2 Dec 20

EGBP CAP 1616 Proposal Submission – Rationale and Assessment of Minor Amendments to the Runway 26 Missed Approach Route.

Fig 1.0 – Minor Amendment to the Missed Approach Route for Runway 26.

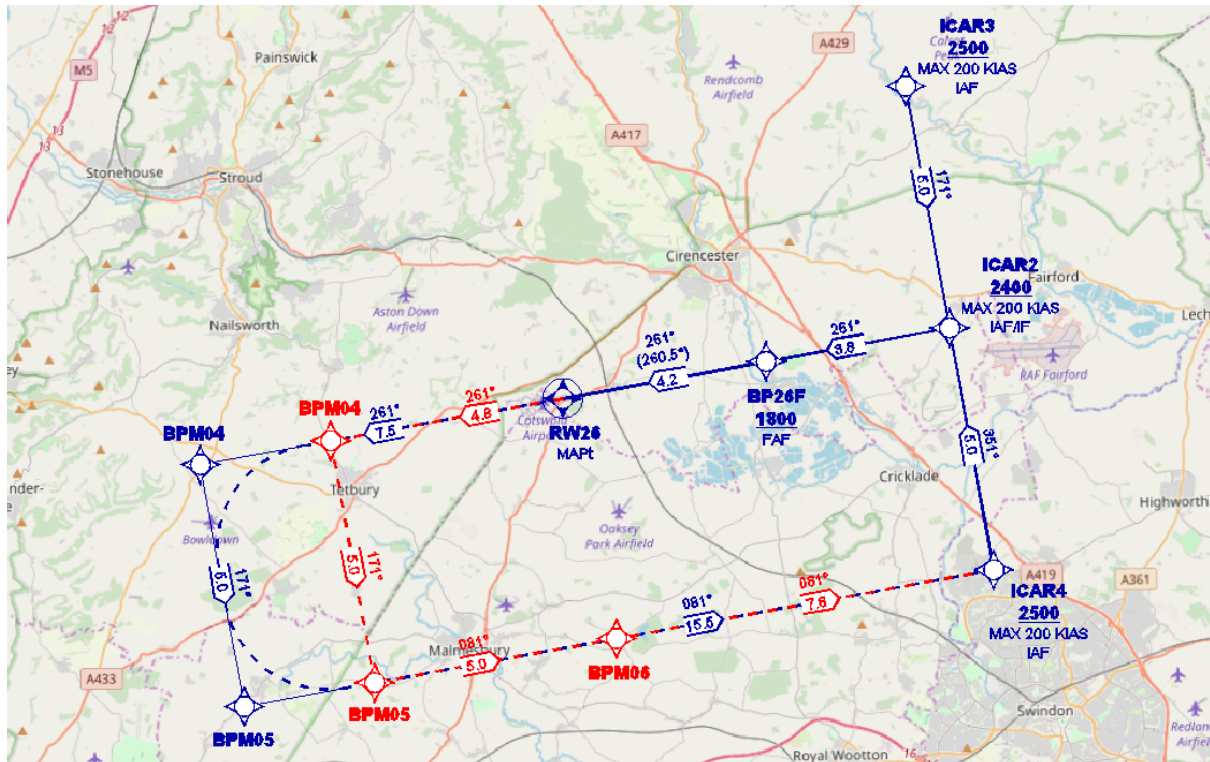
3.2 The change increases the initial climb route distance by 2.7Nm before making the first 90-degree left turn (BPM04). This in turn shifts the entire 2nd segment (crosswind leg BPM04 to BPM05) westwards by 2.7Nm, shifting it from overhead Tetbury and the Restricted Area over Highgrove House (R105) to overhead open countryside, thus avoiding R105 (shown in Fig 2.0). By consequence, this also adds 2.7Nm to the reciprocal leg taking the aircraft back to the IAF.

3.3 This is shown in Fig 1.0, on a ground map, where the red dotted line shows the original proposed missed approach route and the blue line the amended route. The blue dotted line is the most likely actual route flown by aircraft on a missed approach, as the waypoints are fly-by, rather than fly-over.

Fig 2.0 Changes on a VFR Chart

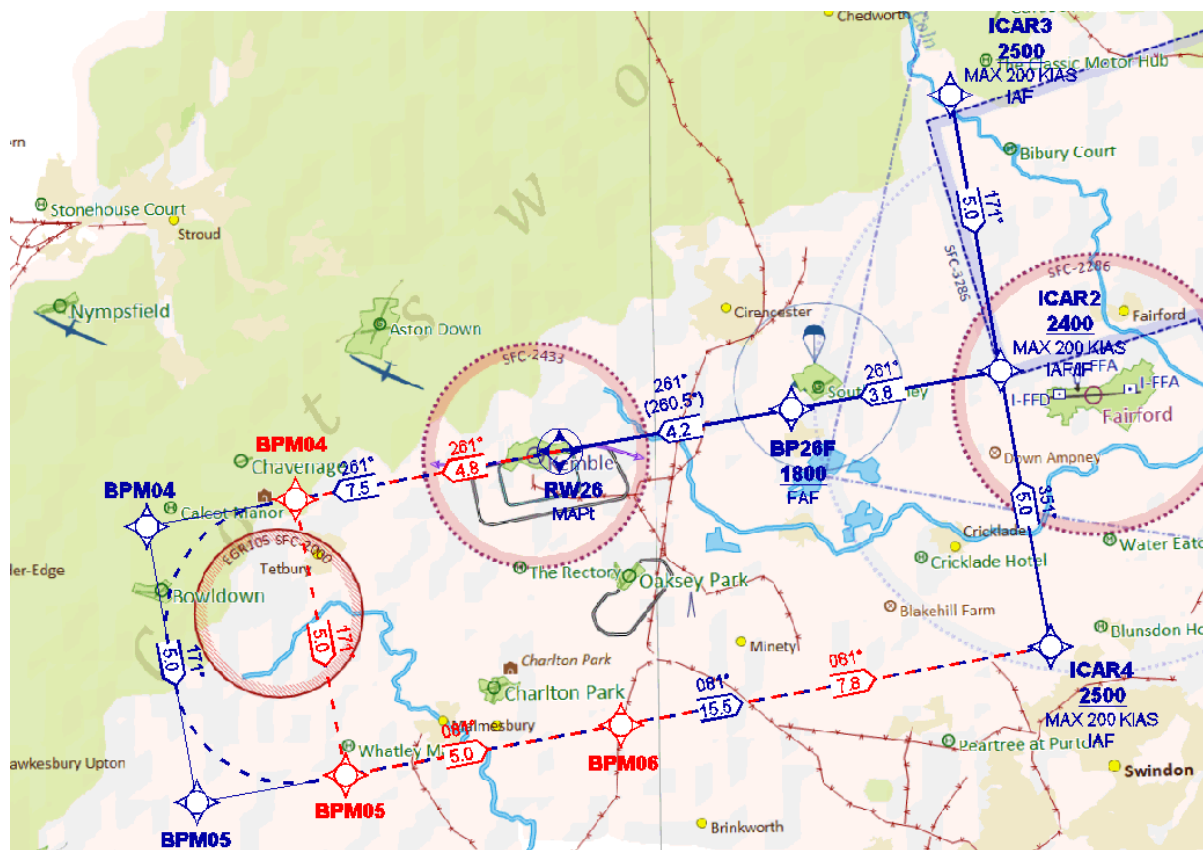
4.3 During detailed technical regulatory approval work for submission and iterative ‘fine-tuning’ by the APDO, the presence of Restricted Area R105, 6nm south west of Cotswold Airport, surrounding the Royal residence at Highgrove House has necessitated an extension of the climb path on runway heading before commencing the first of two 90 degree left turns back to the IAF (ICAR4). Although the climb performance of the bulk of the in-scope aircraft would enable these aircraft to climb above the R105 Restricted Area (above 6% non-

standard climb gradient), a very small number of the largest airliner aircraft may not, thus infringing this restricted area.

4.5 The extension of the missed approach leg, moves the aircraft away from R105, allowing the aircraft to continue its climb to the north of the R105 area, completely avoiding this Restricted Area, meaning even with poor climb performance, there is no potential for infringement, See Fig 2.0, shown on a pilot's (VFR) chart.
